## OFFICER DECISION IN CONSULTATION WITH CABINET MEMBER

### LONG NEWTON – TRAFFIC CALMING

## TRAFFIC CALMING, LONG NEWTON

# Appendix 1

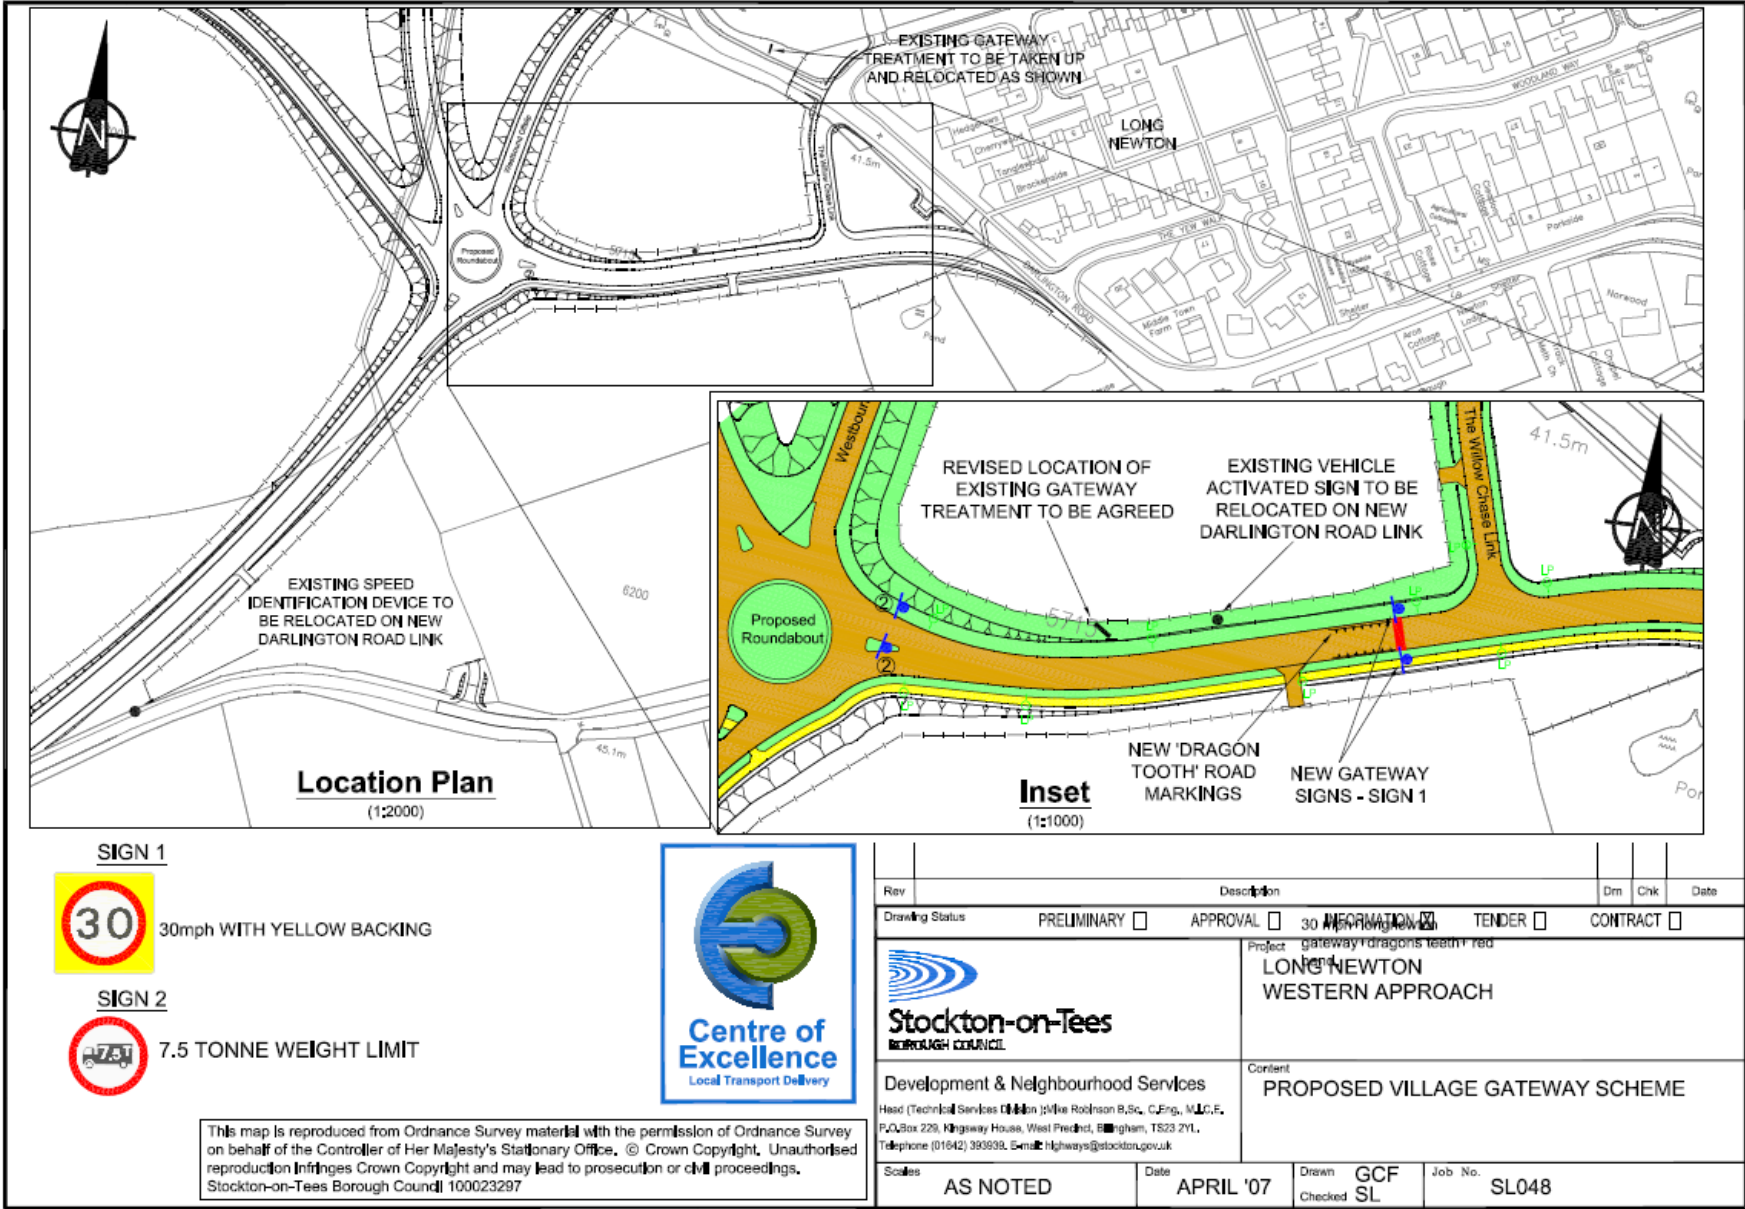
5	x	Re Plan SL048: Gateway signs and 30mph signs are too near the Willow Chase and will impair sight lines when leaving willow chase. 30 signs should be closer to roundabout with later warning system. Is red speeding flush or raised. Re Plan SL047: Disagree with rumble strips, they are not effective and have been found to generate more problems than they solve. Have been removed in other areas of Redcar and Cleveland. Speed humps are ineffective, road narrowing system without humps is better.	The provision of 30mph signs on a 112mm dia pole should not impair visibility. The red coloured rumble strips are thermoplastic the same thickness as normal road markings and should not create too much noise. See comment at 1	
6	<input checked="" type="checkbox"/>	Against traffic calming, speed cushions do not have much effect. Restricted traffic flow is more satisfactory, such a system is in operation in Sedgefield. Residents of Elton are already complaining about speed cushions.	See comment at 1
